Carolina Power & Light Company

OG-137  
Ref: OG-110,  
12/1/83 &  
OG-117  
3/9/84  
October 25, 1984

Westinghouse Owners Group  
Program to Address Generic Letter 83-10 - RCP Trip  
Response to NRC Questions

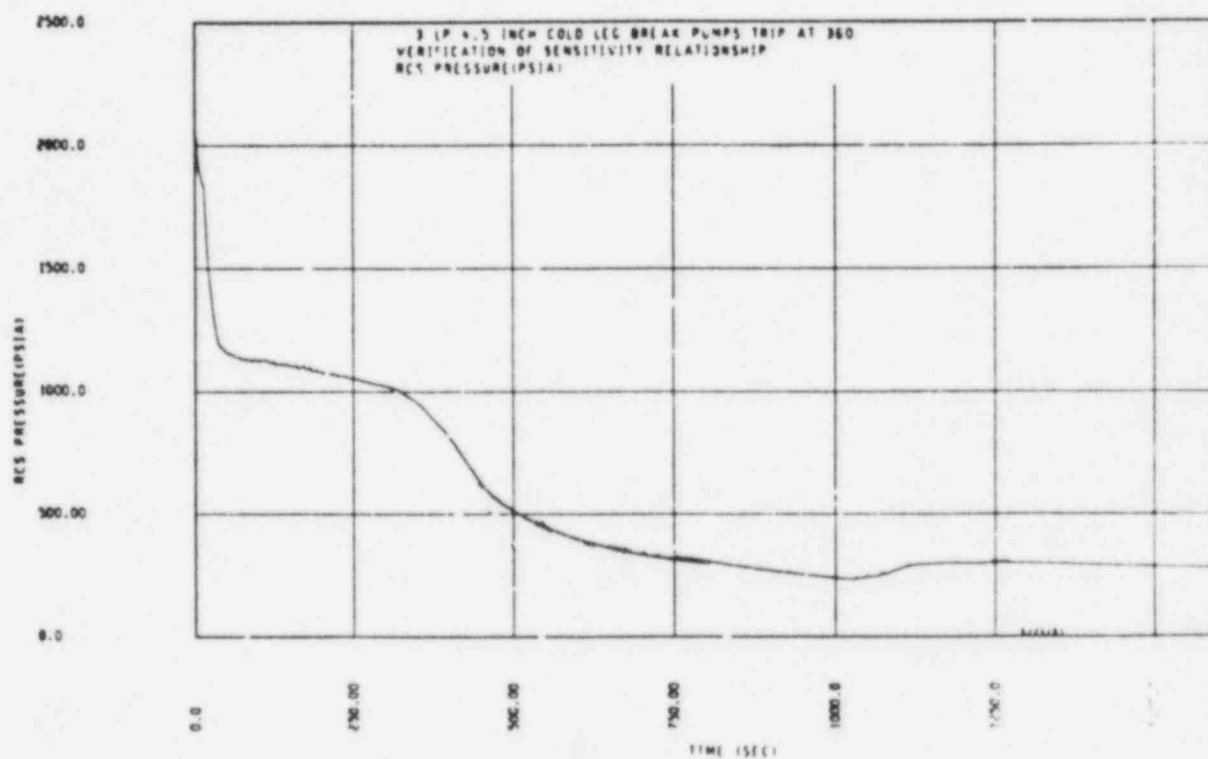
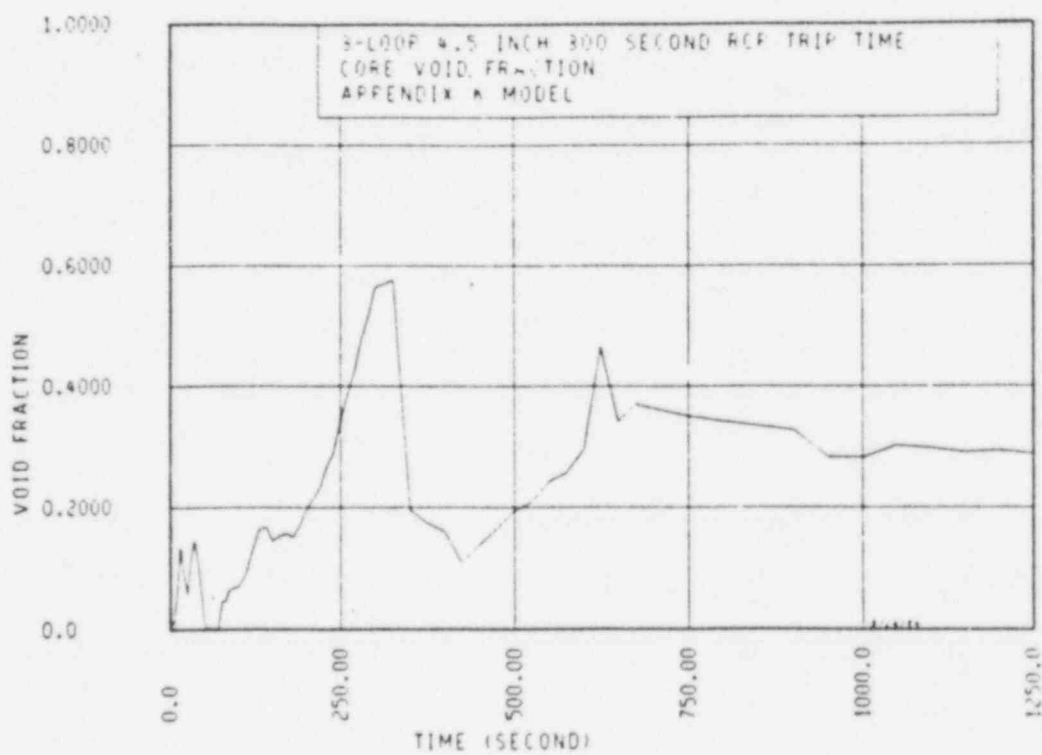
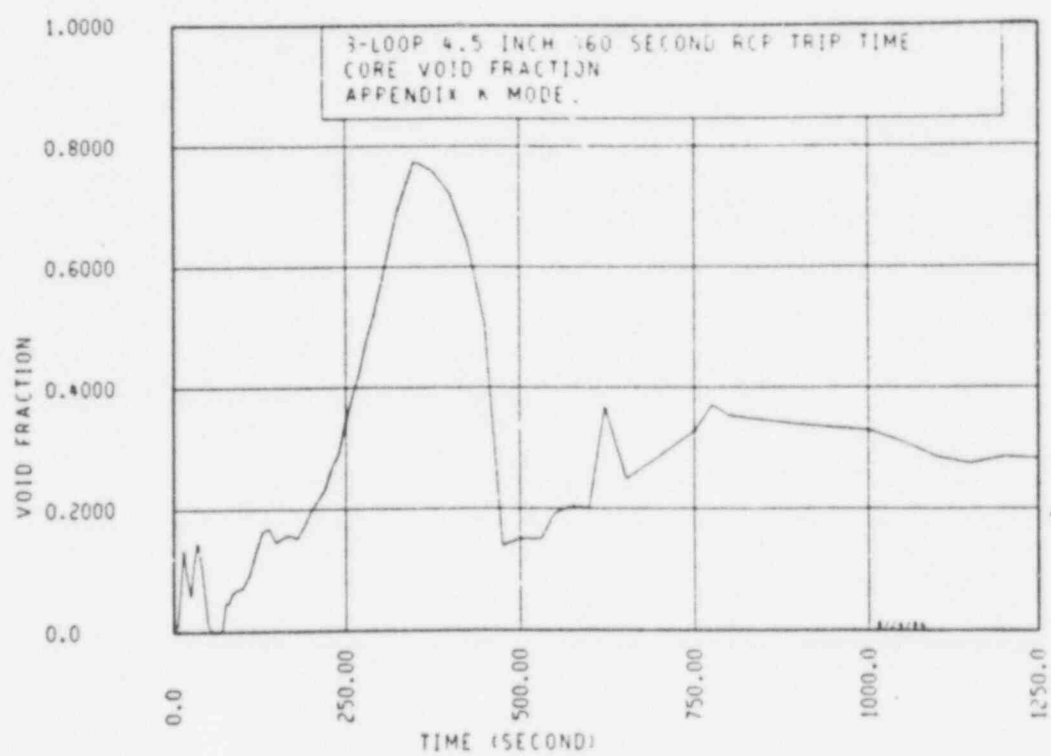
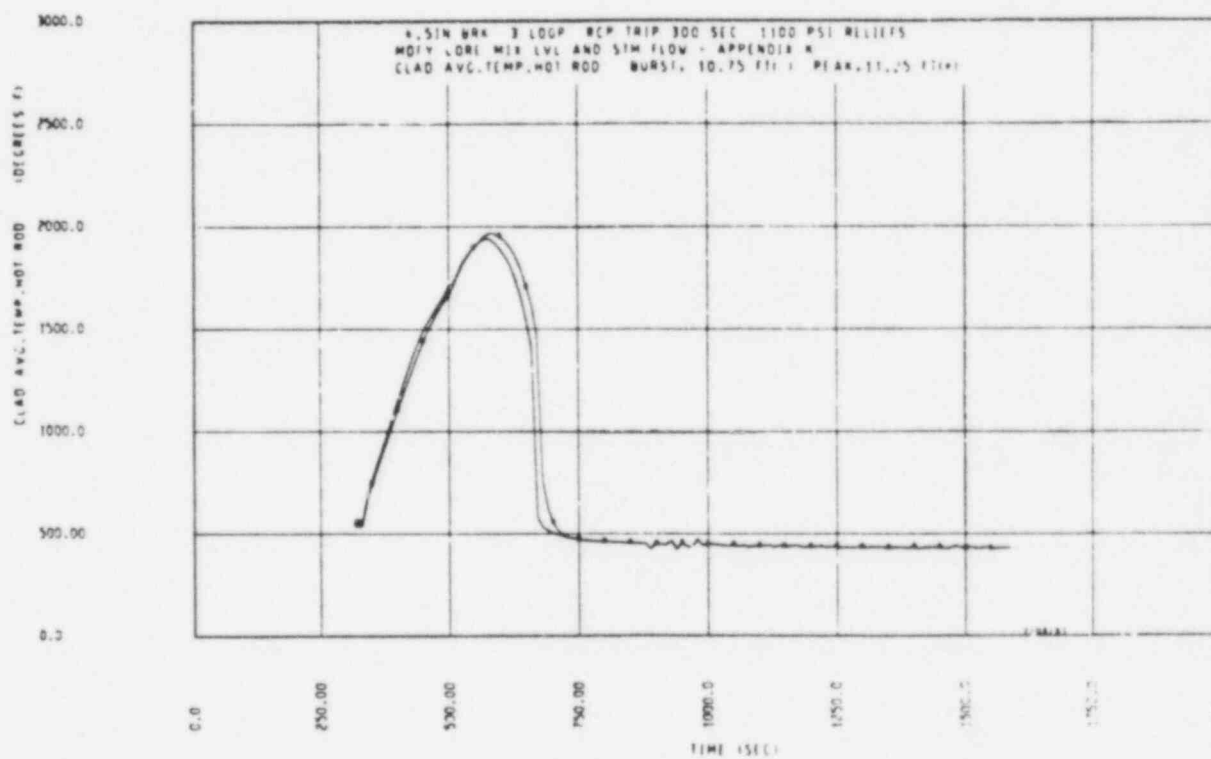
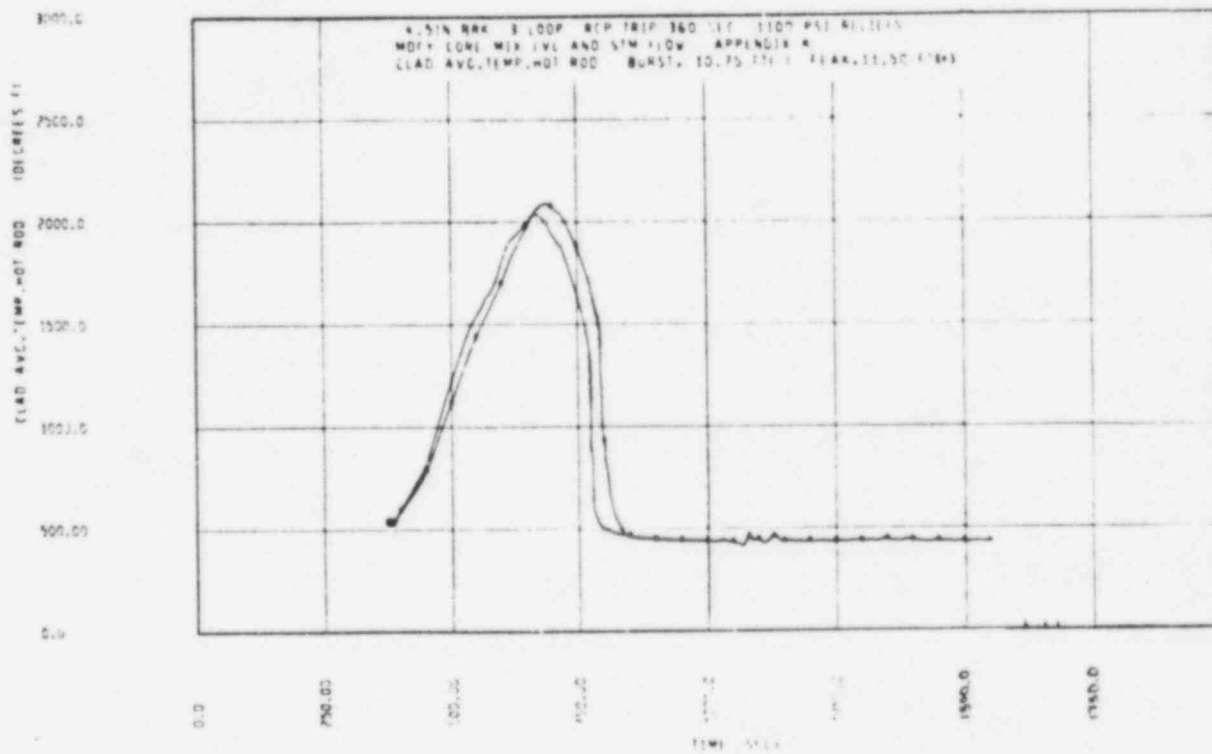
Q.46 Provide the primary pressure, void fraction, and PCT curves for the 300s and 360s RCP trip time cases shown in Figure 4 and 5 of Reference 2.

A.46 See the attached figures.
